# AGENDA

**The Columbia Architectural Design Review Team will meet on Tuesday, June 7th, 2022 at 8:00 a.m. in Conference Room A on the basement level of City Hall, 700 N. Garden Street to consider the following:**

8:10 AM 22-0119 - 2008 Main Street - Modify Façade Of Existing Building  
Request from Richard Thompson on behalf of Ritco Group, Inc for façade modifications at 2008 S. MAIN STREET.

**PLANNING STAFF EVALUATION:**

**Sheet Number**  
**A 3.2**

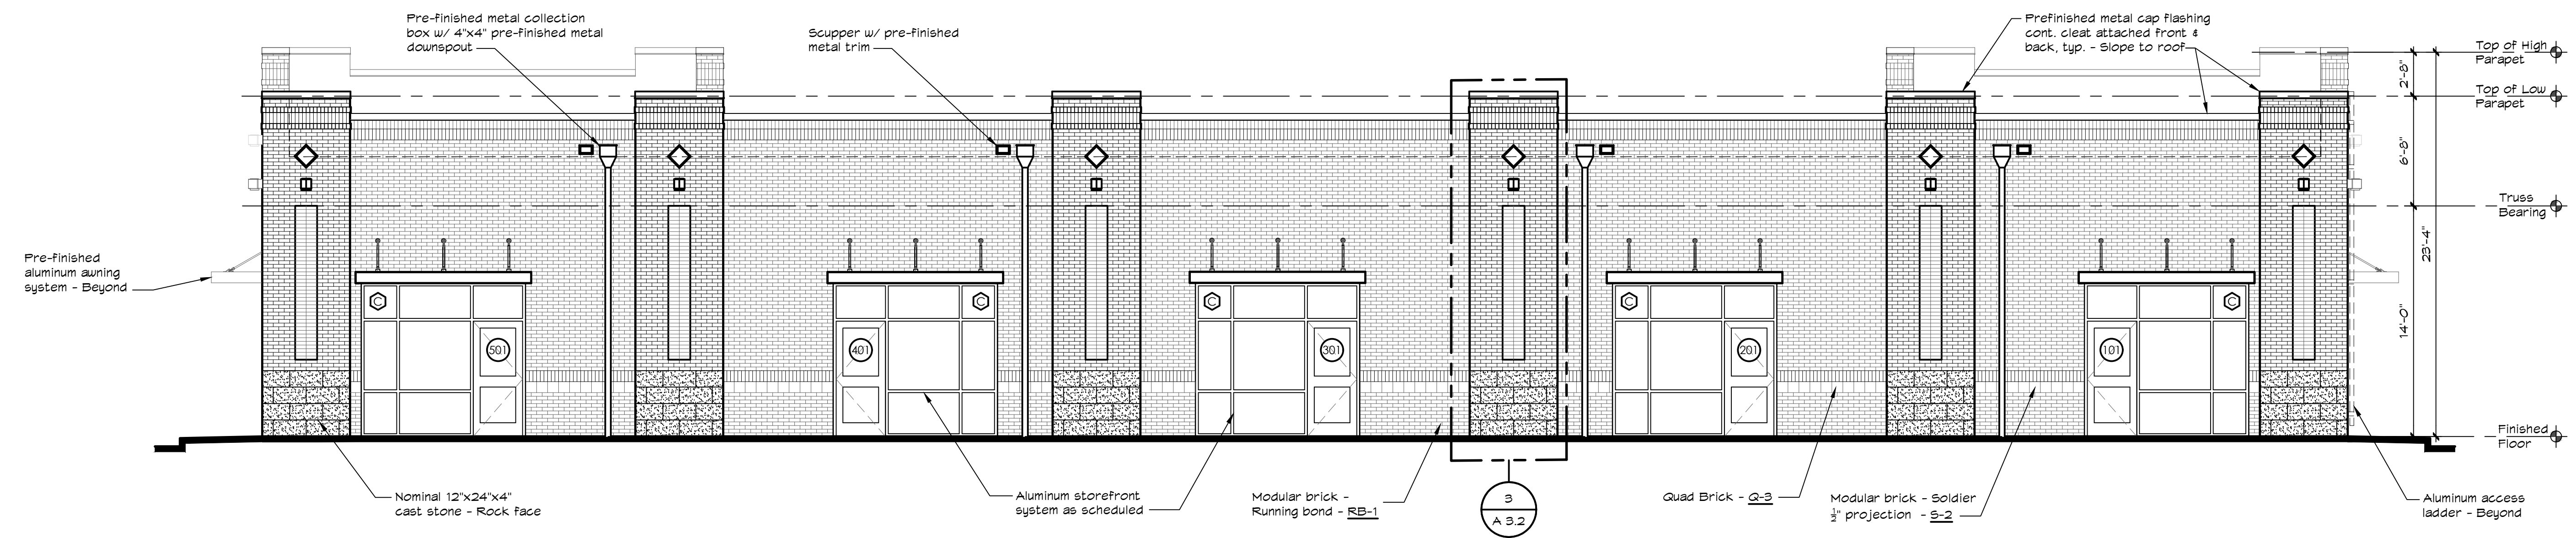
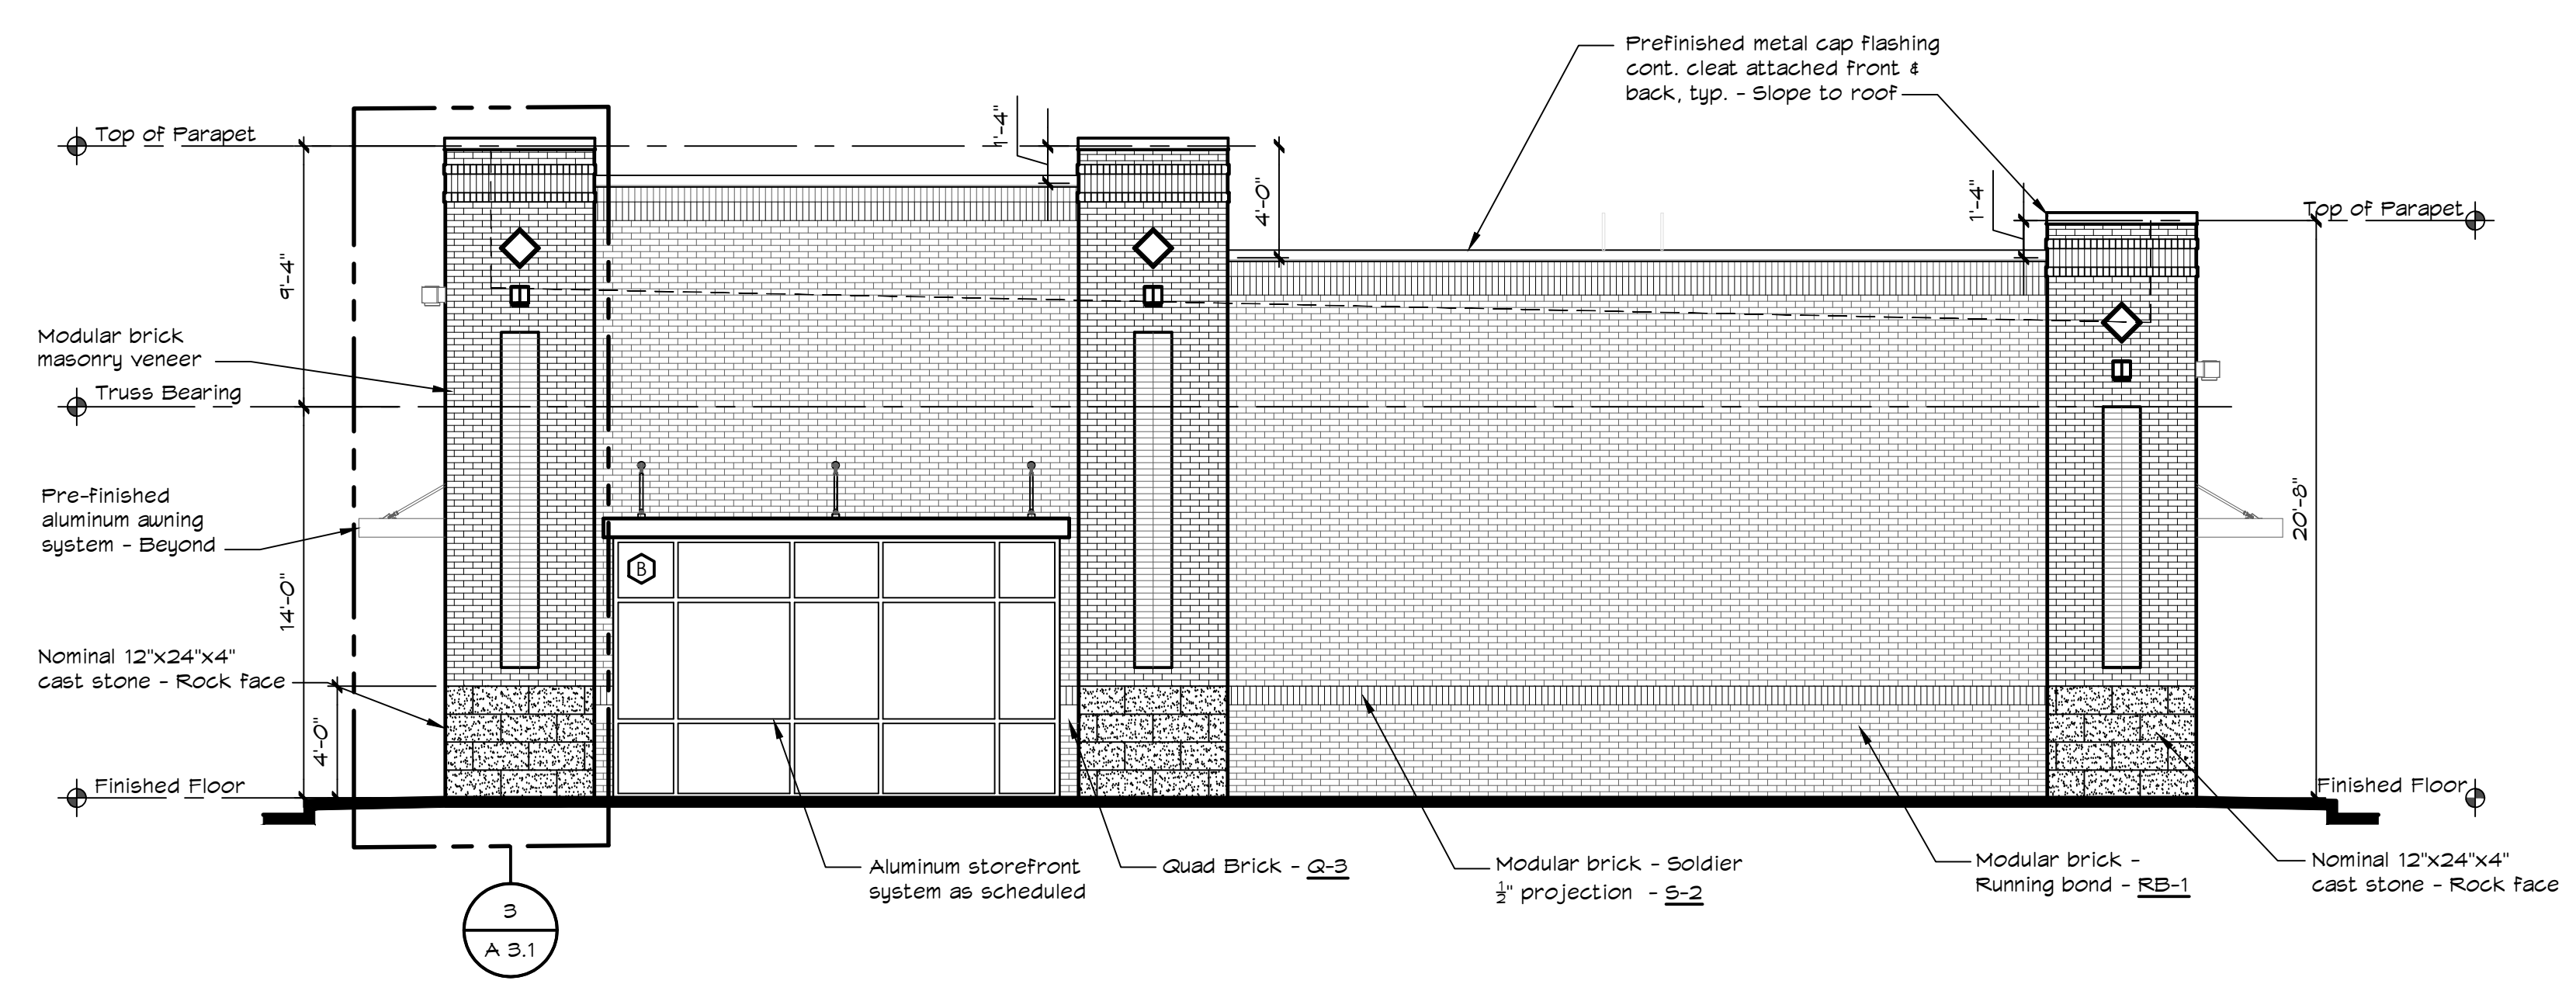
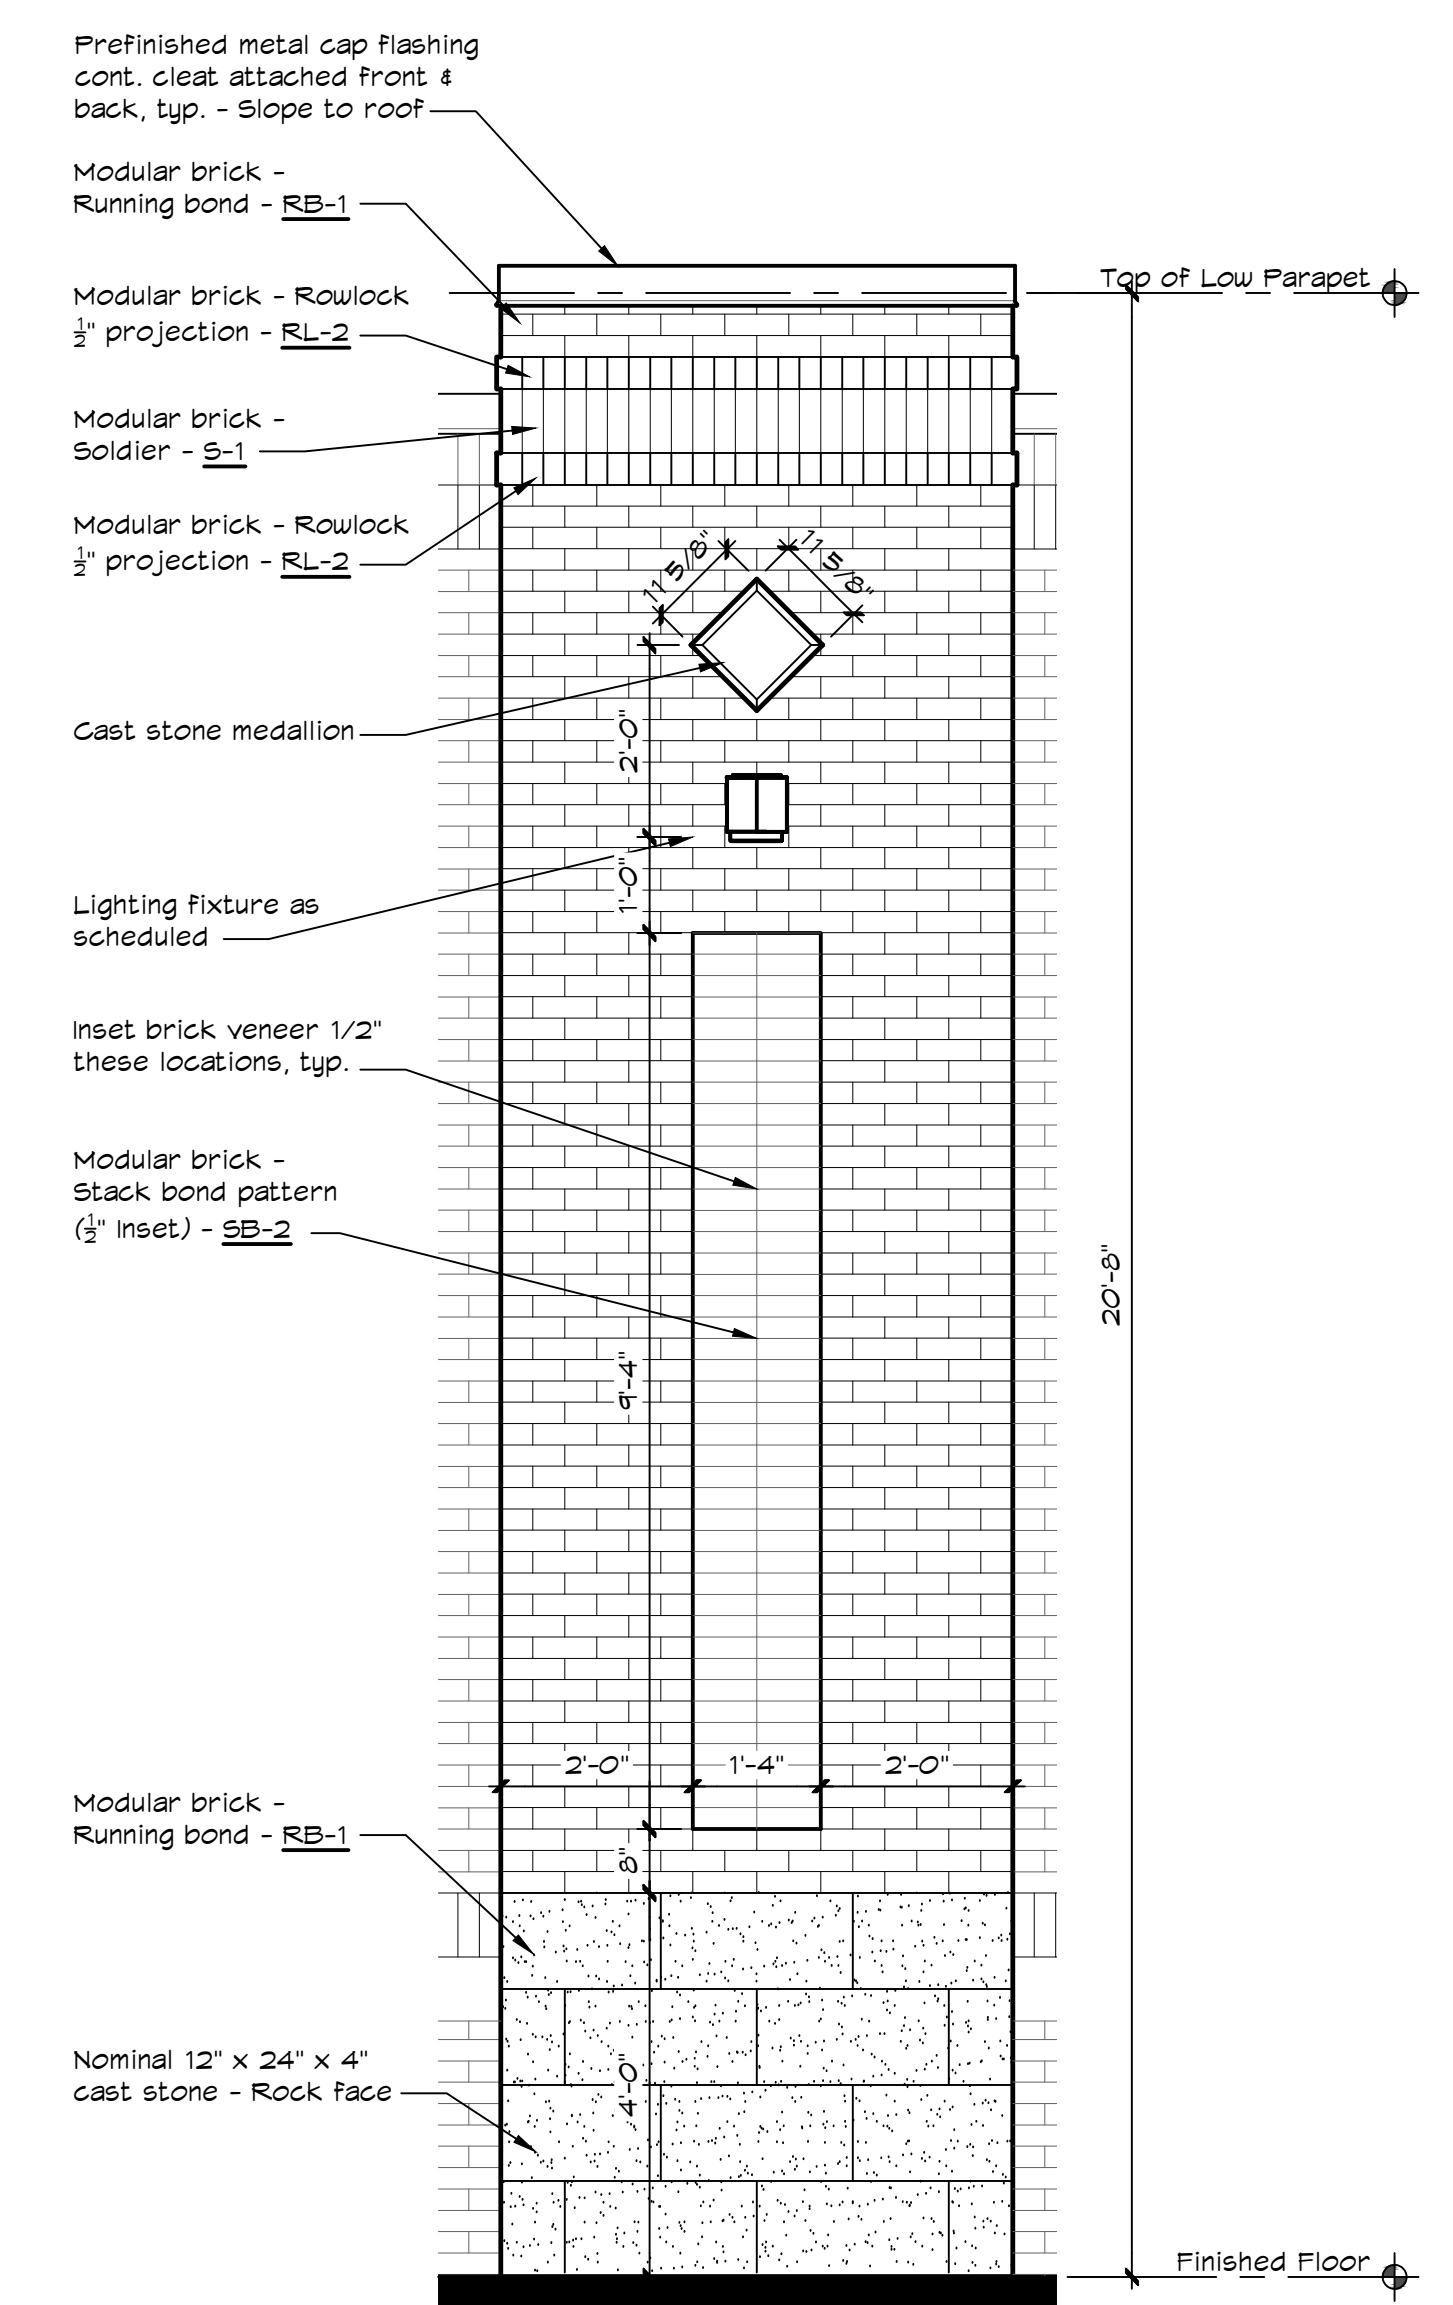
- The proposed west (rear) building elevation will consist of a primary façade material of brick accented by brick soldiering within the base and the columns. Each individual pilaster will be accented by a stone medallion detail. Aluminum storefront windows will be facing the Cayce Lane elevations. The front elevation will consist of the same primary façade materials as the rear elevation with a combination of brick details separated by brick pilasters.
- The right and left (side) elevations will consist of a primary brick material as all other elevations with a 4' recessed parapet.
- It shall be recommended that as a condition of approval that all rooftop HVAC equipment be screened by the raised parapet with no exterior visibility.
